Peel Region

DOCUMENT - 2026-353T
INTERIOR RENOVATIONS FOR PEEL REGIONAL POLICE AT 180 DERRY ROAD EAST, MISSISSAUGA
ADDENDUM NO 2

EMIL V. KOLB CENTRE
PEEL REGIONAL POLICE FACILITY
INTERIOR RENOVATION PROJECT
180 DERRY ROAD EAST, MISSISSAUGA, ON L5T 2Y5

1 A600 PARTIAL GROUND FLOOR PLAN- FILE ROOM
SCALE: 1:50

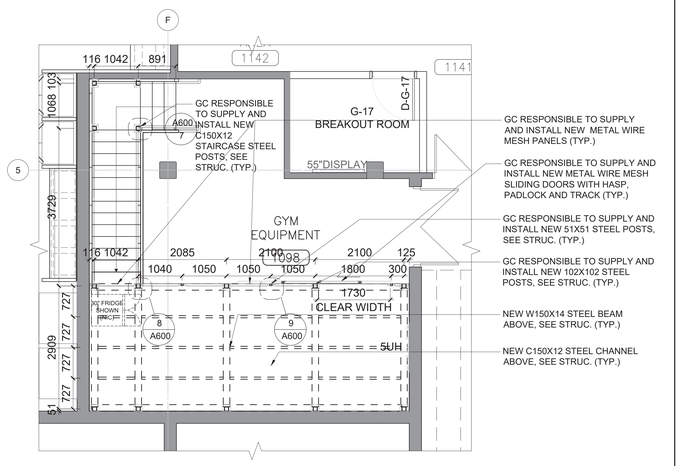
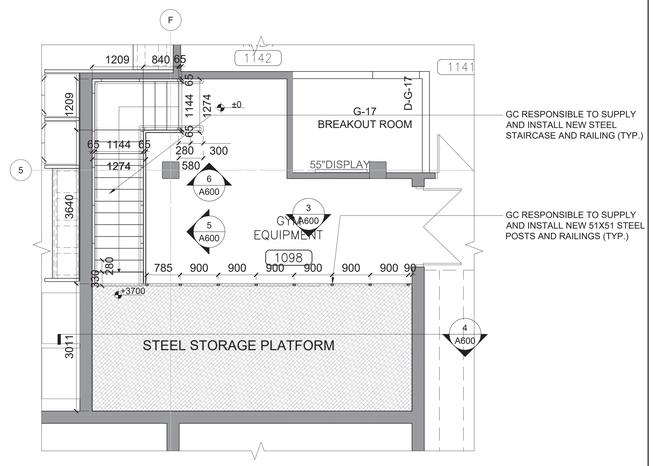
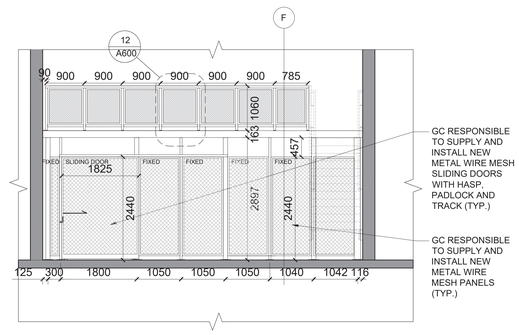
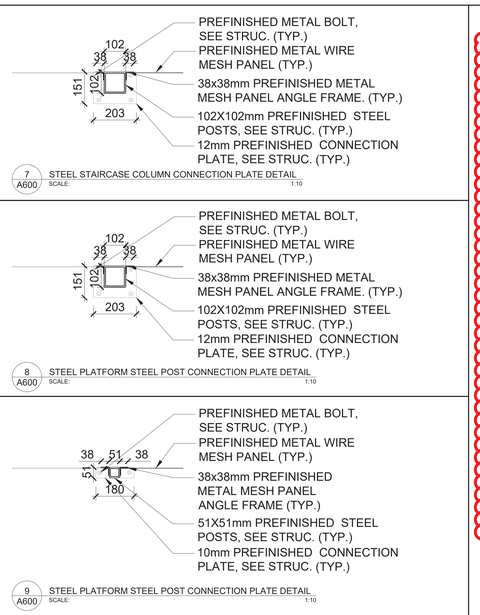
14. Refer to attached drawing A600 for the revised mezzanine detail issued for ADD#02 dated June 15th,2026.

1 M304 PARTIAL THIRD FLOOR PLUMBING PLAN - DEMO
SCALE: 1:100

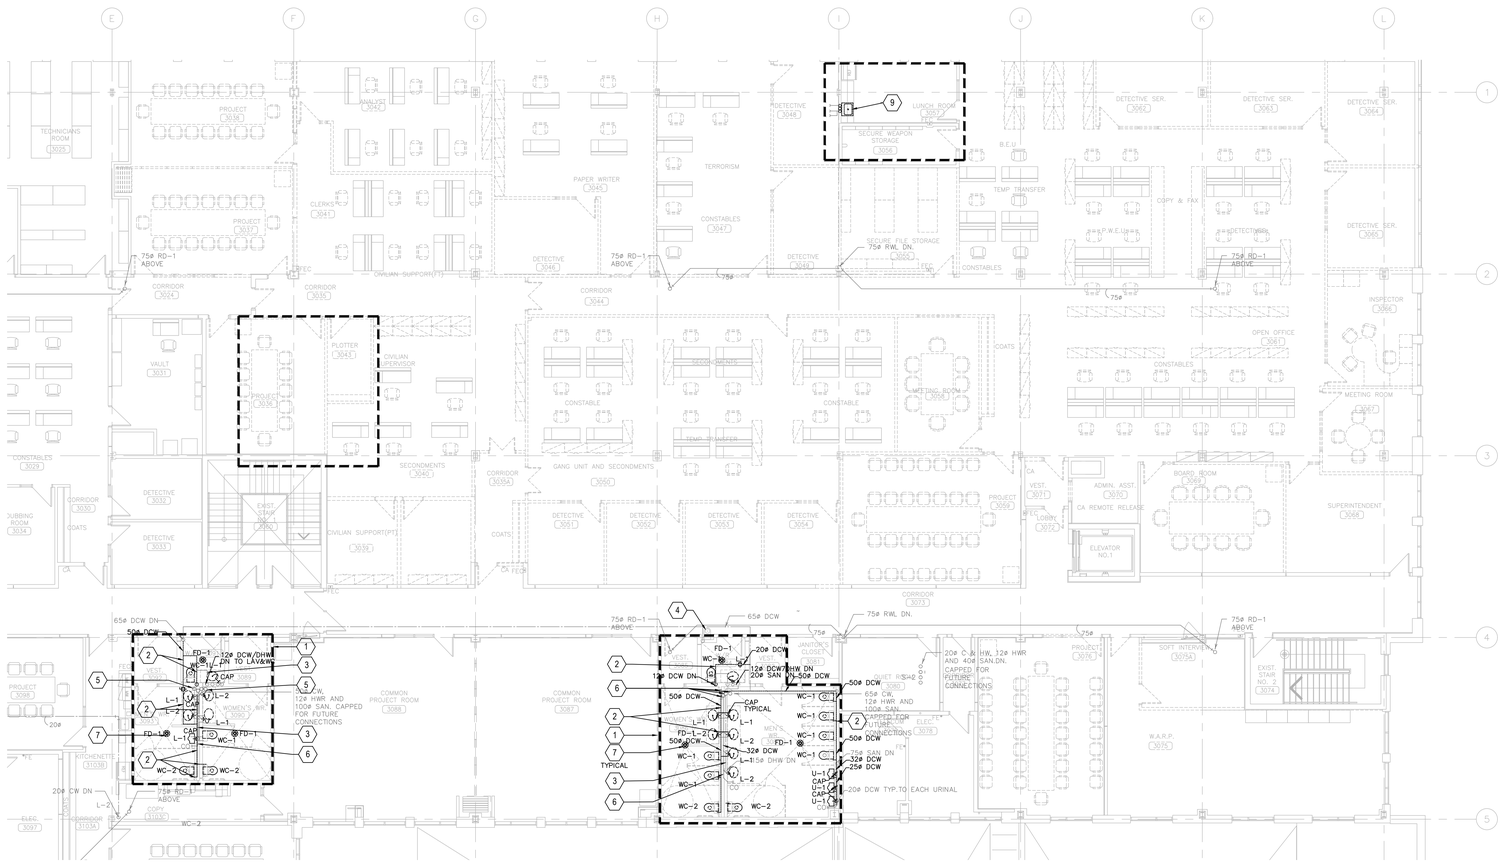
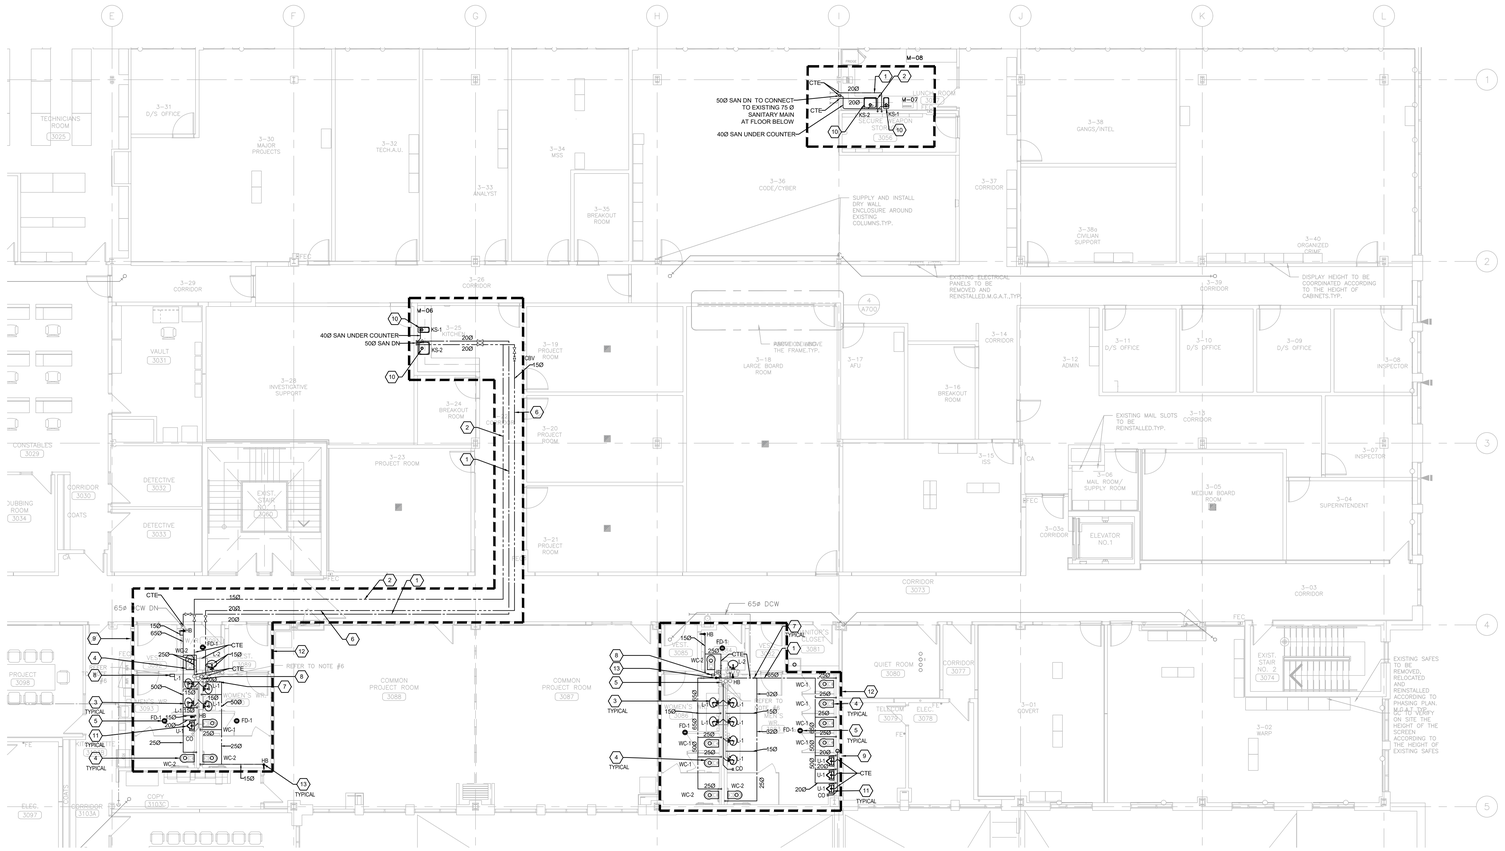
1.1.2. M304 – PARTIAL THIRD FLOOR-PLUMBING DEMO& NEW

.1 New work drawing notes item 1 &2 updated

1.1.6. E301 – ELECTRICAL DETAILS (included herein)

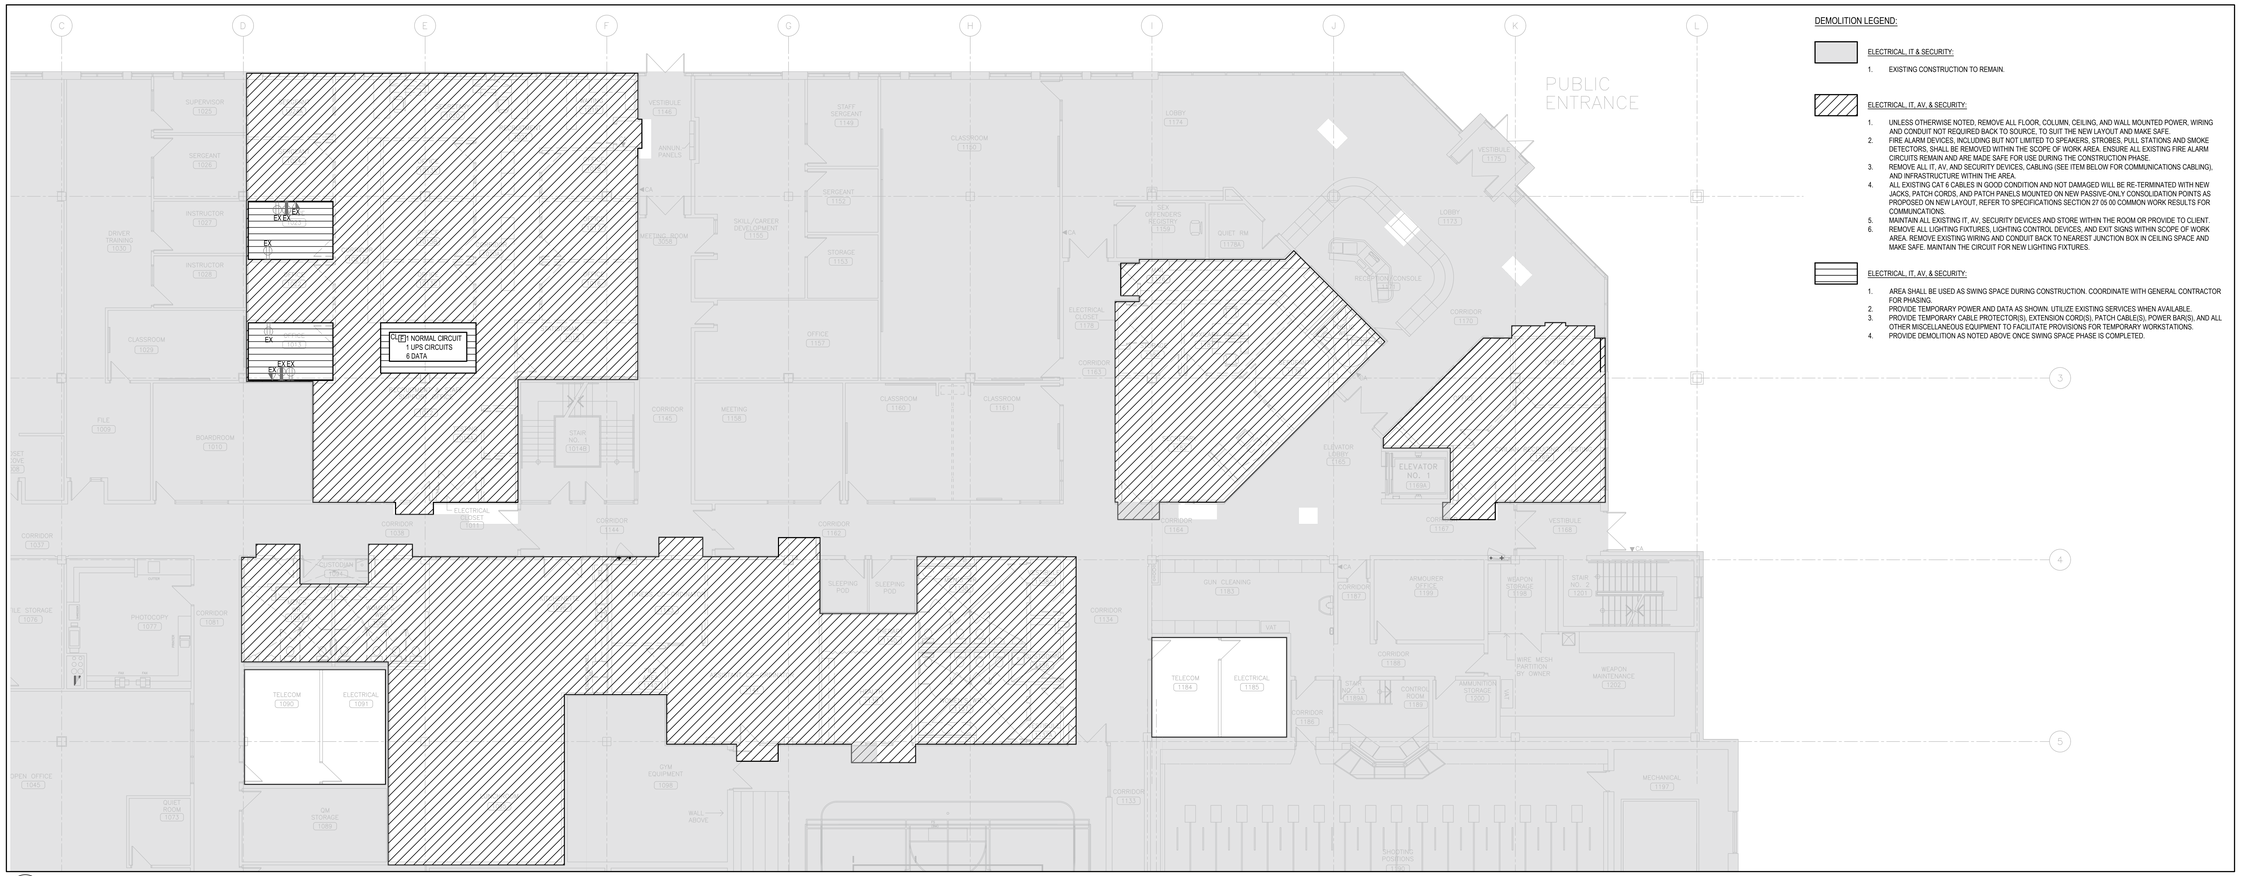
.1 Detail 1: Revise Universal Washroom Wiring Diagram, as bubbled.
